Subject: MHI's Response to US-APWR DCD RAI No. 314-2365 Revision 1

US-APWR Design Certification
Mitsubishi Heavy Industries
Docket No. 52-021

15.06.01 - INADVERTENT OPENING OF A PWR PRESSURIZER

QUESTION NO.: 15.6.1-1

Figure 15.6.1-1.1 Steam Generator Pressure versus Time Inadvertent Opening of a Depressurization Valve

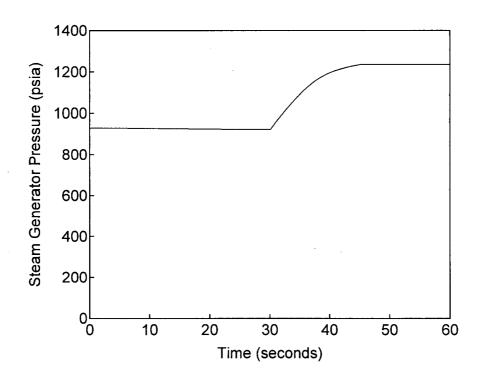
Provide the transient curve for steam generator pressure verses time in the FSAR Section 15.6.1 analysis.

The transient curve for steam generator pressure versus time for the DCD Subsection 15.6.1 analysis is shown below in Figure 15.6.1-1.1. The SG safety valve is modeled assuming 103% of the SG design pressure (1236 psia). This shows that the SG pressure is maintained well below 110% of design pressure.
